Access Compliance Report Public Rights-of-Way (Curb Ramps)

Main Street: **MERCANTILE_WAY** Cross Street: **1ST_ST** Location: **SW**

ADA ID: **RPRK211027173208** Ramp Type: **Type 4 - Parallel** Initial Pass/Fail: **Fail** Overall Compliance: **No** Severity Score: **16**

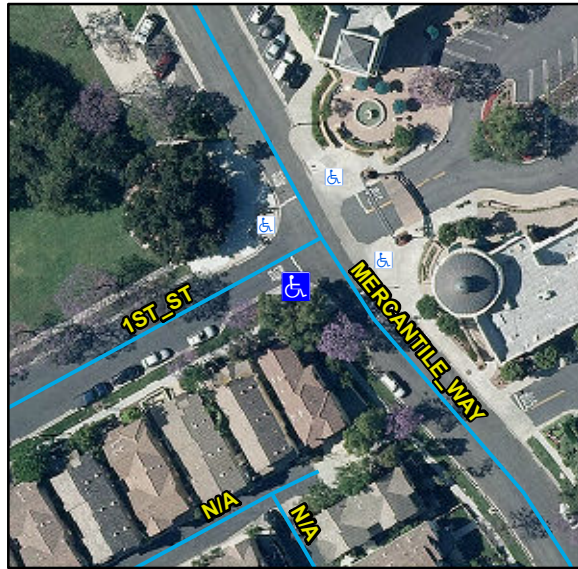
Compliance	Description	Data	Compliance	Description	Data
N/A	Ramp Length LT (in)	106	N/A	Ramp Length RT (in)	116
Yes	Ramp Width LT (in)	89	Yes	Ramp Width RT (in)	89
No	Ramp Run Slope LT (%)	9.7	Yes	Ramp Run Slope RT (%)	1.3
No	Ramp Cross Slope LT (%)	3.2	Yes	Ramp Cross Slope RT (%)	1.6
N/A	Landing Present	N/A	N/A	DWS Provided	N/A
N/A	Landing Length (in)	N/A	N/A	DWS Contrast	N/A
N/A	Landing Width (in)	N/A	N/A	DWS Length (in)	N/A
N/A	Landing Run Slope (%)	N/A	N/A	DWS Full Width	N/A
N/A	Landing Cross Slope (%)	N/A		DWS Offset Type	N/A
N/A	Landing Movement Obstructed?	N/A	N/A	DWS Offset Left (in)	N/A
	Landing Movement Type	N/A	N/A	DWS Offset Right (in)	N/A
N/A	Landing Shared	N/A			
N/A	Clear Space	Yes			
N/A	Clear Space To Crosswalk (in)	N/A			
N/A	Marked Crosswalk 1	No	N/A	Marked Crosswalk 2	No
	Crossing 1 Direction	E		Crossing 2 Direction	N
	Marked Crosswalk 1 Width (in)	N/A		Marked Crosswalk 2 Width (in)	N/A

Remove & Replace Curb Ramp With Two New Directional Ramps or Equivalent.

R204.3, R304.3.2, R304.5.3, STD 1115
